Wisconsin Department of Transportation

Proposal #04: 1100-15-71
Milwaukee – Fond du Lac Rd
Box Culvert B-66-0195
USH 41
Washington County

This is Addendum No. 01, which provides for the following:

Addendum No. 01
 ID 1100-15-71
 Revised Sheet 21
 May 27, 2015

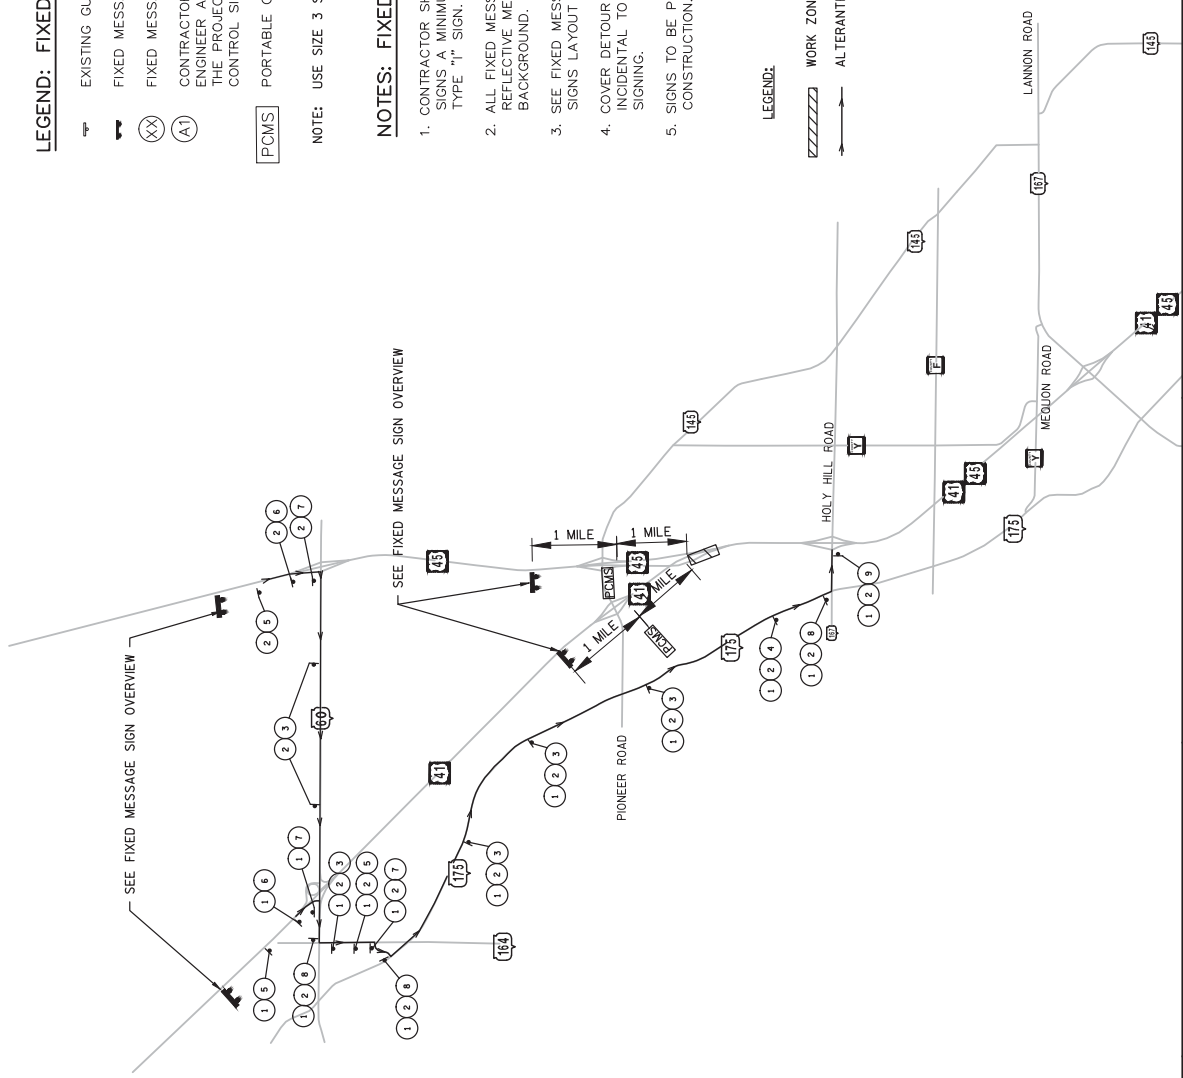
Revised Plan Sheets – 1100-15-71	
Plan Sheet	Plan Sheet Title (brief description of changes to sheet)
11	1100-15-71 – PLAN DETAIL (revised guardrails and grading details)
21	1100-15-71 – ALTERNATE ROUTE (revised alternate route for USH 45 SB traffic)
28	1100-15-71 – MISCELLANEOUS QUANTITIES (revised guardrail bid items schedule)
29	1100-15-71 – MISCELLANEOUS QUANTITIES (revised traffic control bid items schedules)
85	1100-15-71 – STRUCTURE B-66-195 (revised to delete concrete weir wall & revised riprap)
87	1100-15-71 – STRUCTURE B-66-195 (revised to delete concrete weir wall & revised riprap)
90	1100-15-71 – STRUCTURE B-66-195 (revised to delete concrete weir wall & revised riprap)
91	1100-15-71 – STRUCTURE B-66-195 (revised to delete concrete weir wall & revised riprap)

Addendum No. 01
ID 1100-15-71
Added Sheet 62A
May 27, 2015

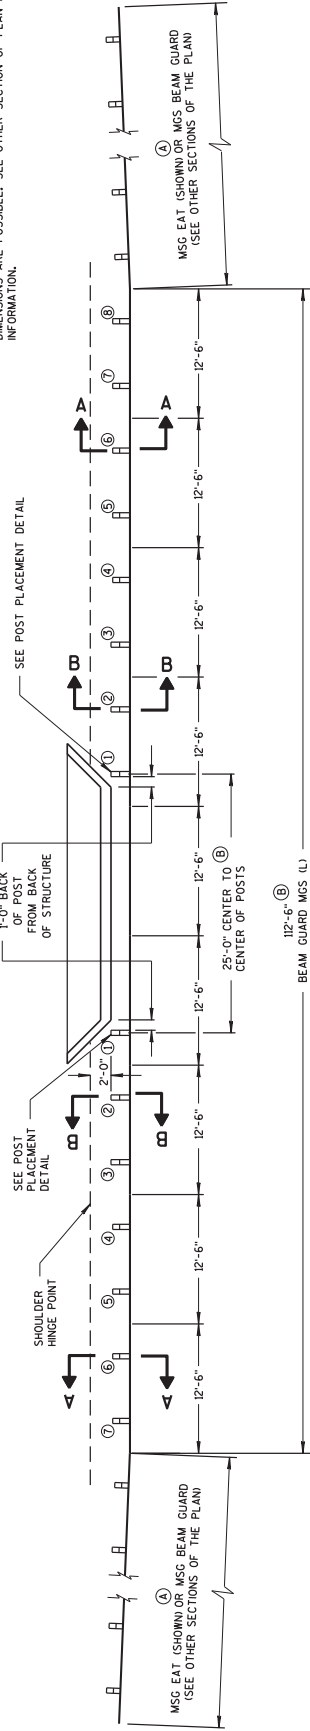
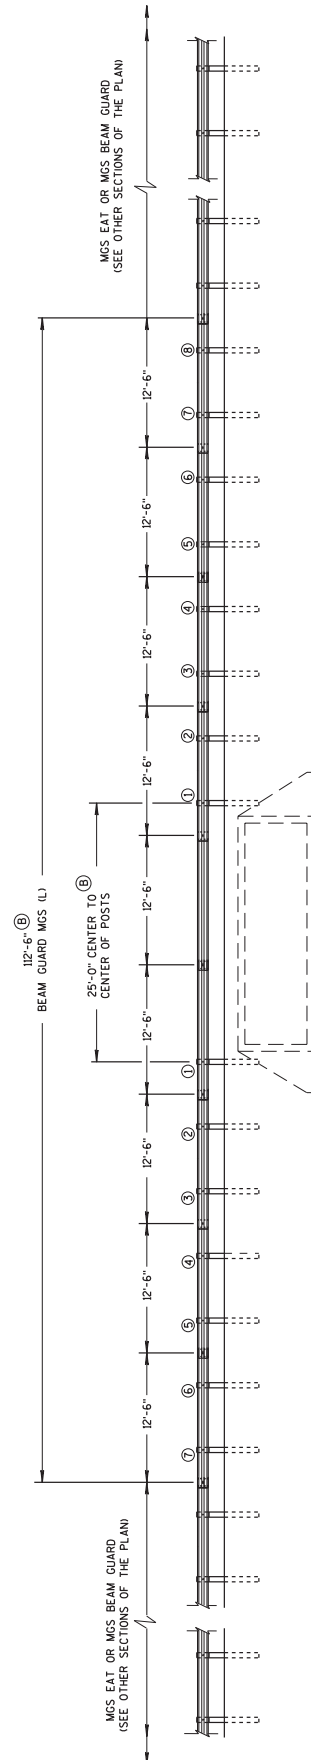
Added Plan Sheets – 1100-15-71	
Plan Sheet	Plan Sheet Title (brief description of why sheet was added)
62A	1100-15-71 – SDD 14B43-3a – Midwest Guardrail System Long Span MGS (L)
62B	1100-15-71 – SDD 14B43-3b – Midwest Guardrail System Long Span MGS (L)
62C	1100-15-71 – SDD 14B43-3c – Midwest Guardrail System Long Span MGS (L)
97A	1100-15-71 – CROSS SECTIONS (revised guardrail and grading details)
97B	1100-15-71 – CROSS SECTIONS (revised guardrail and grading details)

Addendum No. 01
ID 1100-15-71
Revised Sheet 85
May 27, 2015

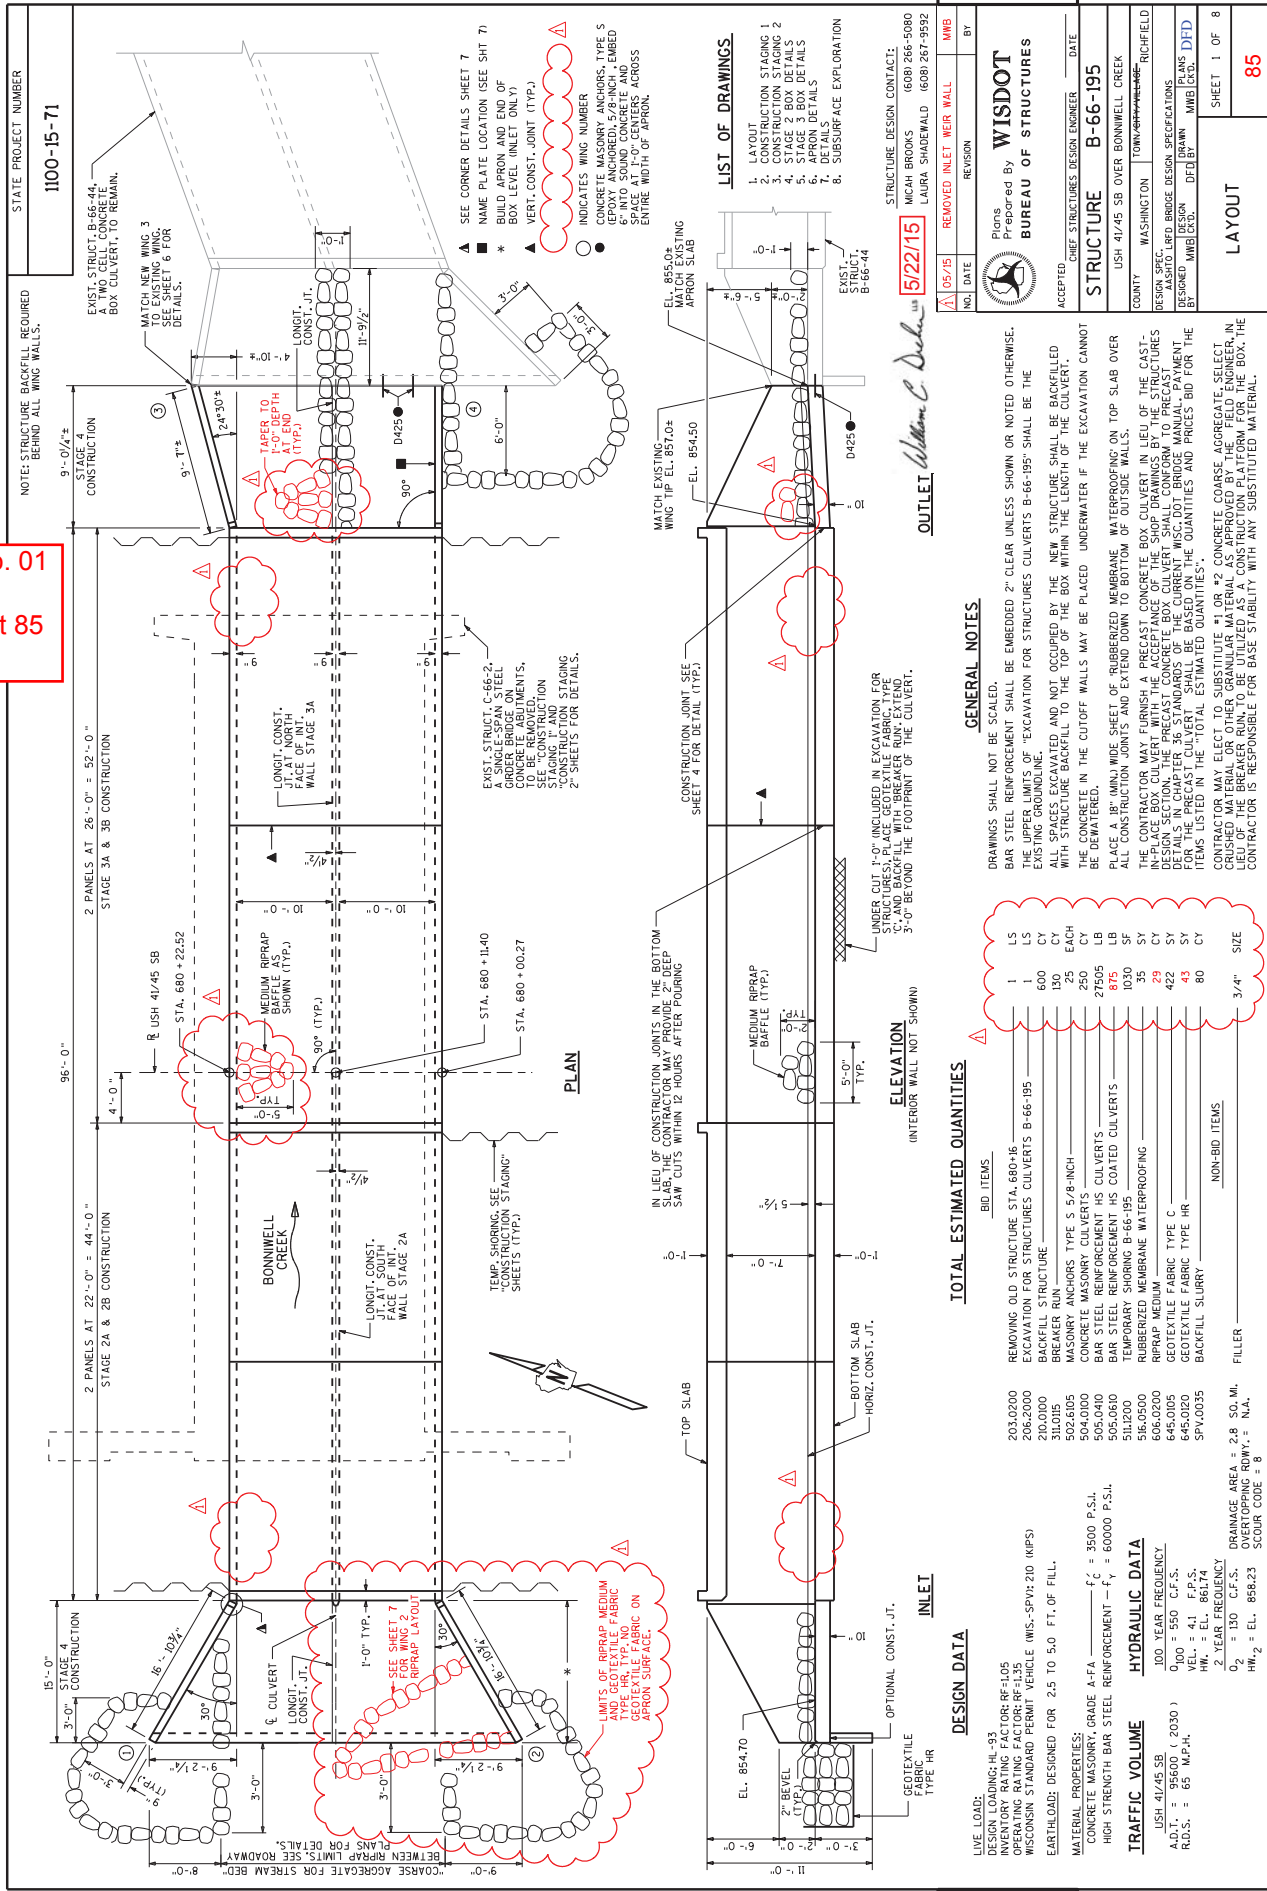
REMOVED INLET WEIR WALL
 WMB
 NO. DATE REVISION BY

Addendum No. 01
 ID 1100-15-71
 Revised Sheet 87
 May 27, 2015

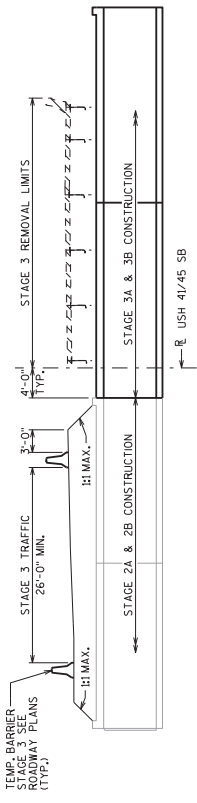
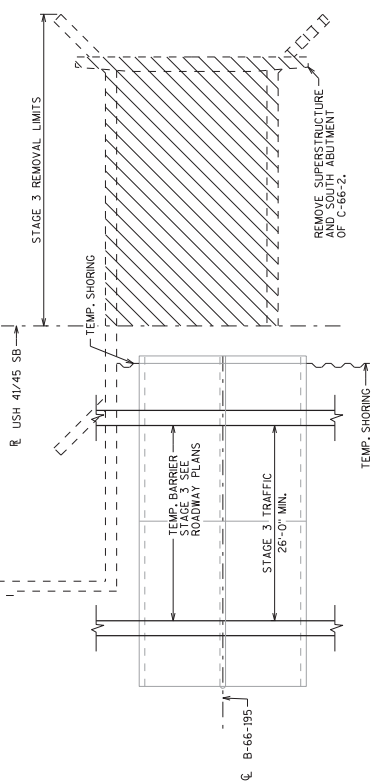
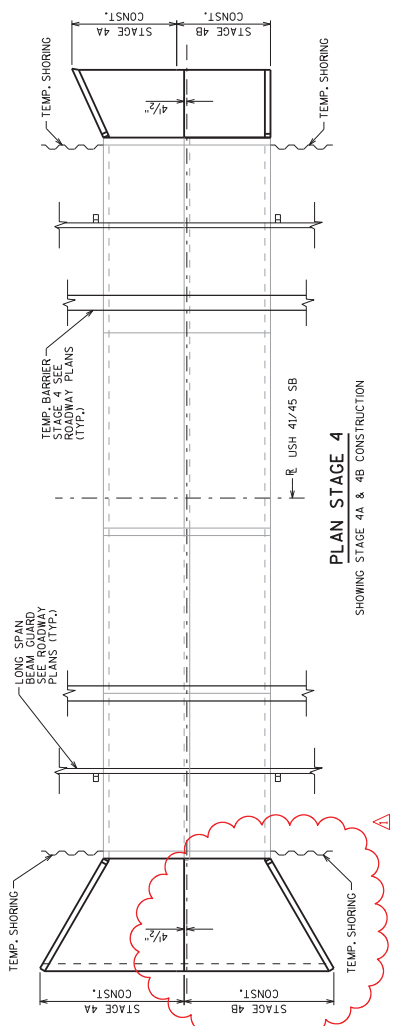
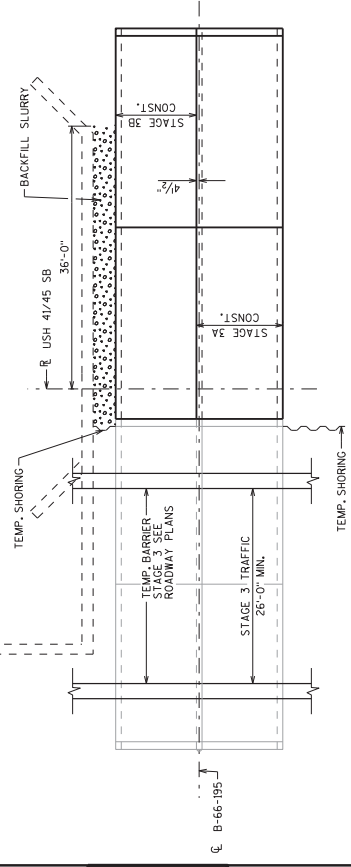
REMOVED INLET WEIR WALL

Addendum No. 01
ID 1100-15-71
Revised Sheet 90
May 27, 2015

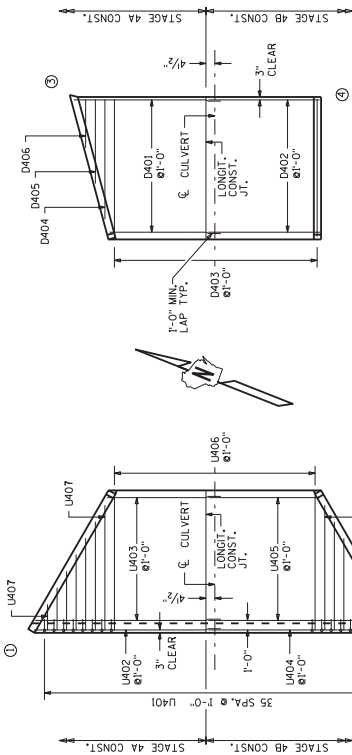
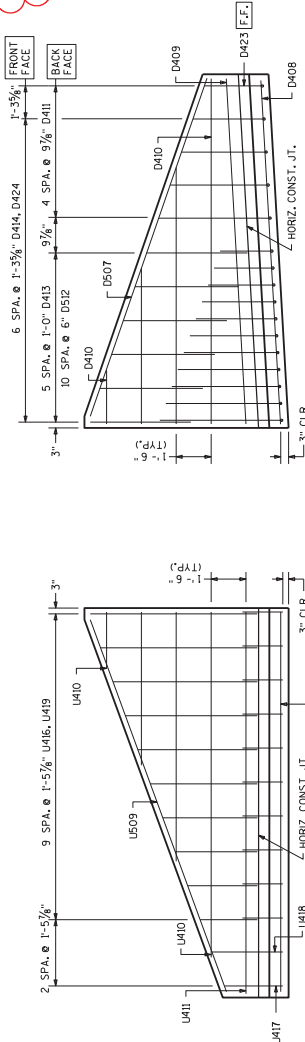
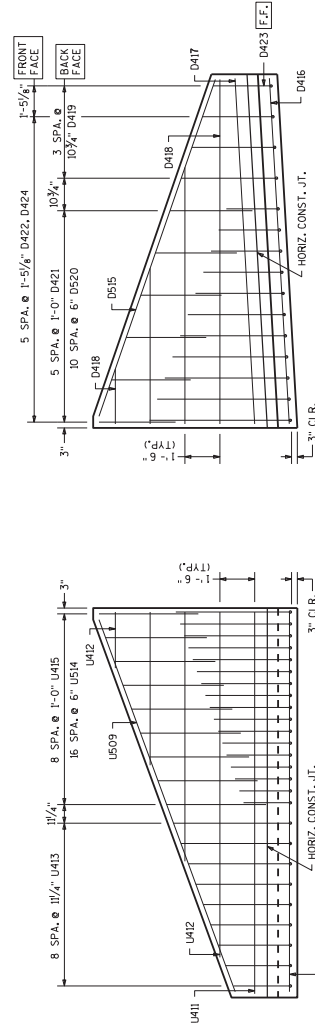
NO.	DATE	REVISION	BY
05/15		REMOVED INLET WER WALL	MMB

Addendum No. 01
ID 1100-38-70
Revised Sheet 85
May 27, 2015

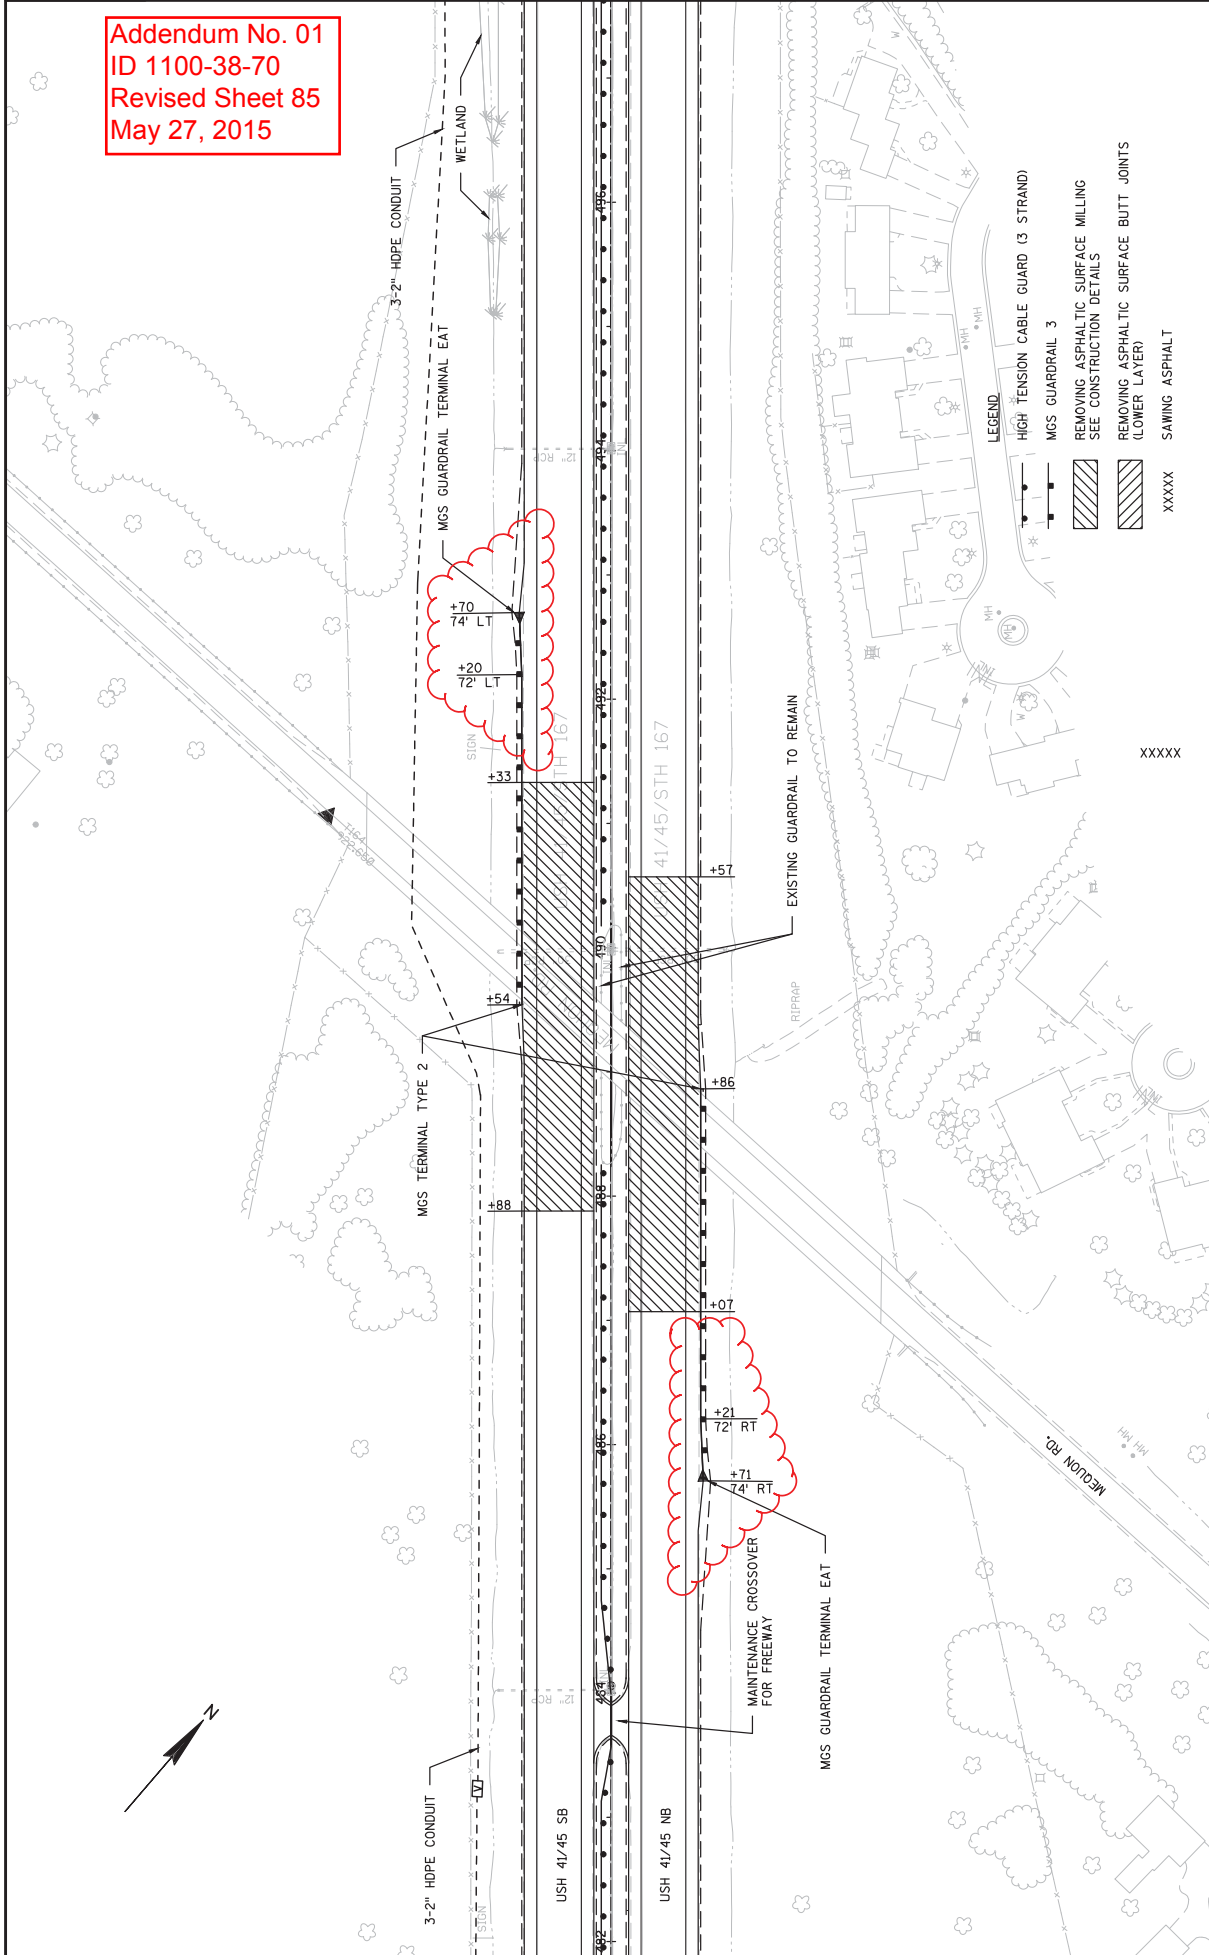
83	1100-38-70 – PLAN DETAIL (revised asphaltic shoulders, guardrails, & grading details)
85	1100-38-70 – PLAN DETAIL (revised asphaltic shoulders, guardrails, & grading details)
92	1100-38-70 – PLAN DETAIL (revised asphaltic shoulders, guardrails, & grading details)
93	1100-38-70 – PLAN DETAIL (revised asphaltic shoulders, guardrails, & grading details)
97	1100-38-70 – PLAN DETAIL (revised asphaltic shoulders, guardrails, & grading details)
98	1100-38-70 – PLAN DETAIL (revised asphaltic shoulders, guardrails, & grading details)
387	1100-38-70 – FIXED MESSAGE SIGN DETAILS (revised sign details to US 41 & US 45)
390	1100-38-70 – DETOUR PLANS (revised detour signs)
391	1100-38-70 – DETOUR PLANS (revised detour signs)
392	1100-38-70 – DETOUR PLANS (revised detour routes & detour signs)
393	1100-38-70 – DETOUR PLANS (revised detour routes & detour signs)
394	1100-38-70 – DETOUR PLANS (revised detour routes & detour signs)
